SAFETY EVALUATION BY THE OFFICE OF NUCLEAR REACTOR REGULATION

SUPPORTING POWER INCREASE TO 500 Kw

FACILITY OPERATING LICENSE NO. R-75

OHIO STATE UNIVERSITY

Figure 1: Schematic Diagram of the OSURR Cooling System

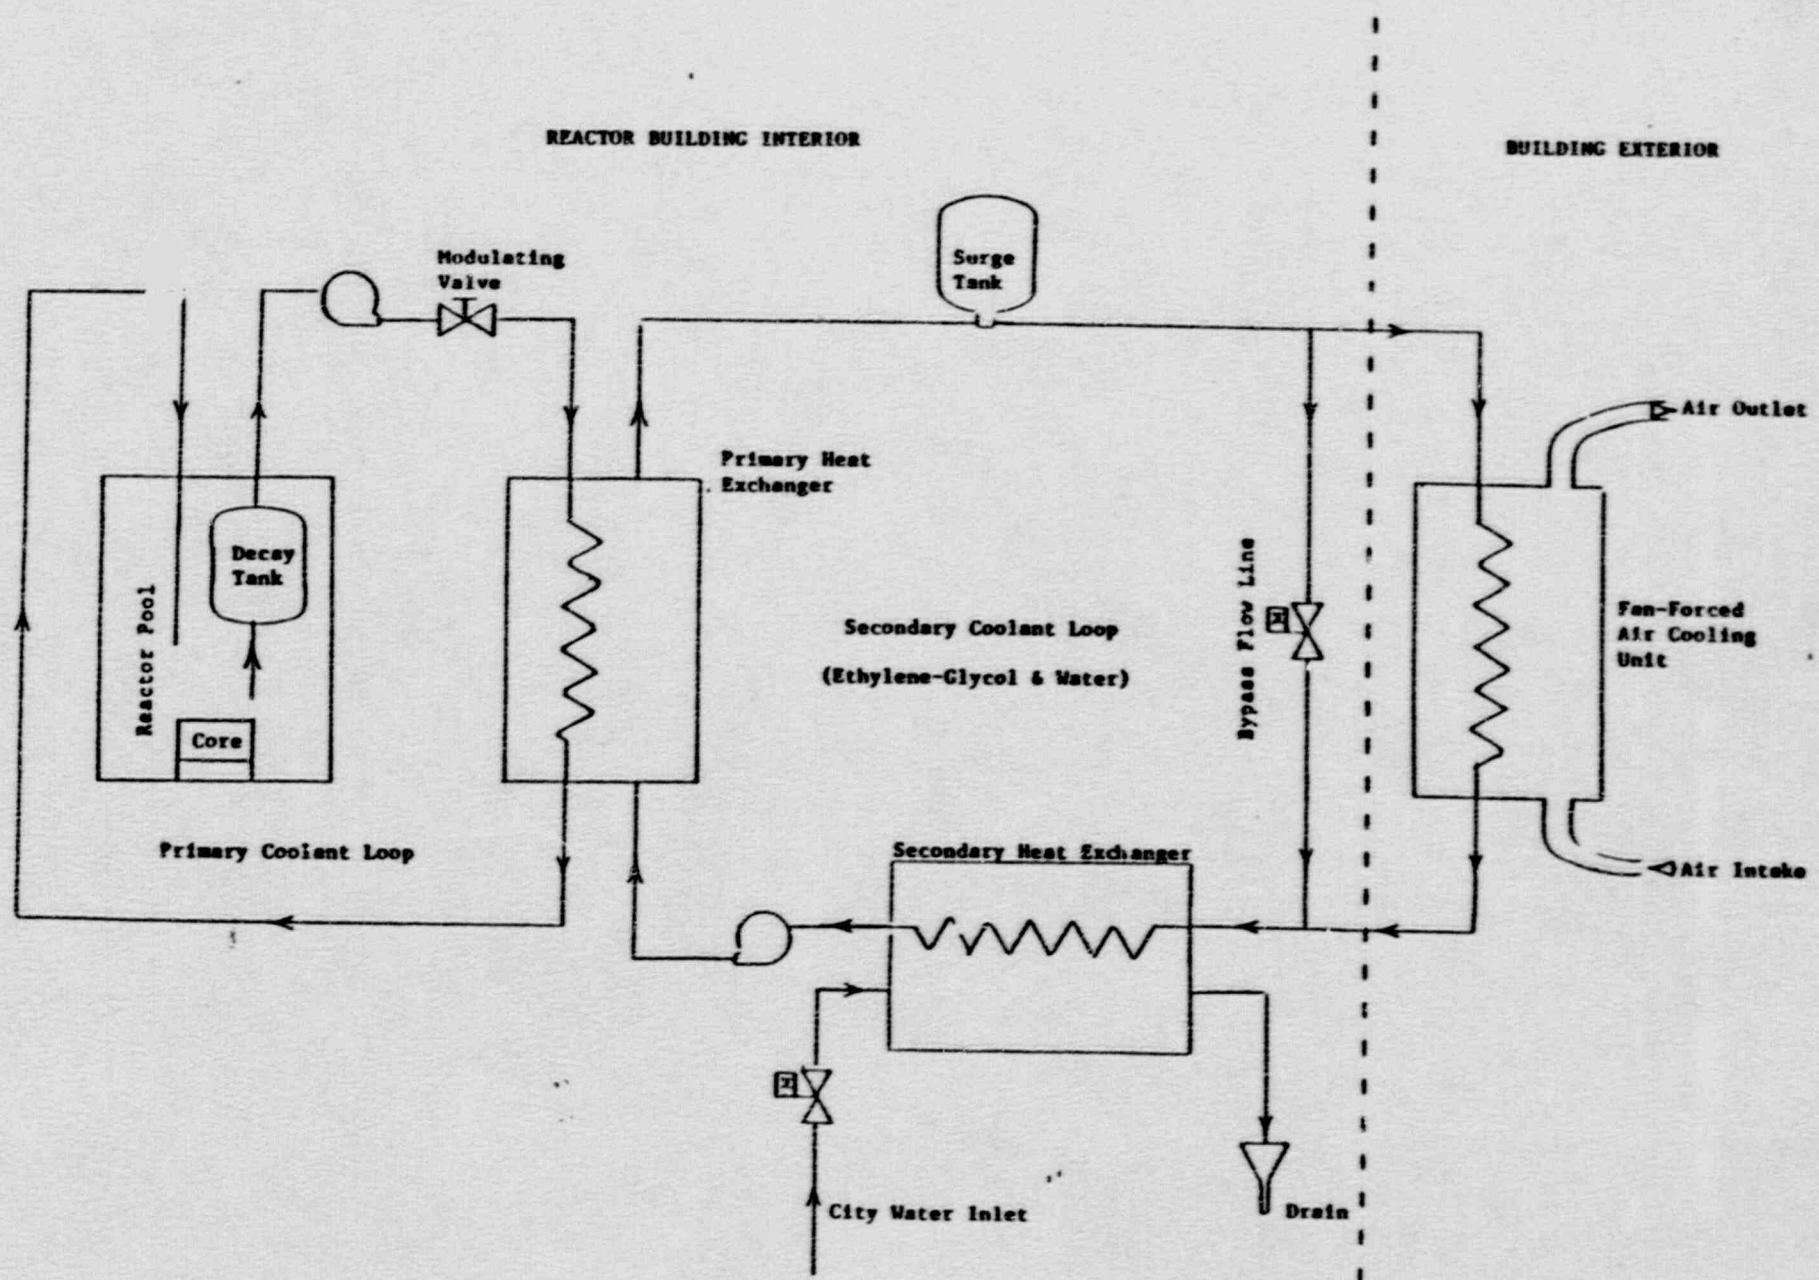
The potential risk to the public health and safety, is due to the increase in the radioactivity of the coolant. This will be the largest effect on the cooling and purification system that results from the power increase to 500 kW. An analysis of the system shows that there is very little possibility that reactor coolant will enter the city water supply because of the design features that use pressure differential, check valves, and manual shutoff valves. However, reactor coolant could enter the city sewer system through the floor drain from a loss from the primary coolant loop or a loss from the purification system, caused by pipe failure. The licensee and the staff have examined possible failure scenarios and have concluded the most adverse radiological consequences would result from the inadvertent loss of a maximum of 870 gallons of water because of a break in the primary piping upstream of the check valve, which would lower the reactor pool water to the syphon break. Assuming this

water was at the highest credible activation level, OSURR personnel have estimated a maximum radioactivity level in the city sewer system of 5.3×10^{-6} $\mu\text{Ci}/\text{cc}$ for sodium-24, and a maximum tritium concentration after operating for 25 years of less than 10^4 $\mu\text{Ci}/\text{cc}$, both of which are well below the limits in 10 CFR Part 20 for water discharge to an unrestricted area, even if no further dilution were to occur.

1. The new OSURR cooling system components are of appropriate size, design, and condition to ensure adequate operation of the reactor under routine operating conditions specified in the OSURR operating license at power levels up to 500 kW.
2. The OSURR primary coolant purification system is of proper size, design, and condition to ensure that the quality of the coolant water remains sufficiently high to preclude significant water corrosion damage to the core or structure under all operating conditions permitted in the operating license.
3. The OSURR cooling system is designed such that an inadvertent injection of primary water into the city water supply system is not credible. An inadvertent release of up to 870 gallons of primary water to the city sewer system is credible; however, the associated radioactivity release is well below NRC regulatory limits, and is acceptable.
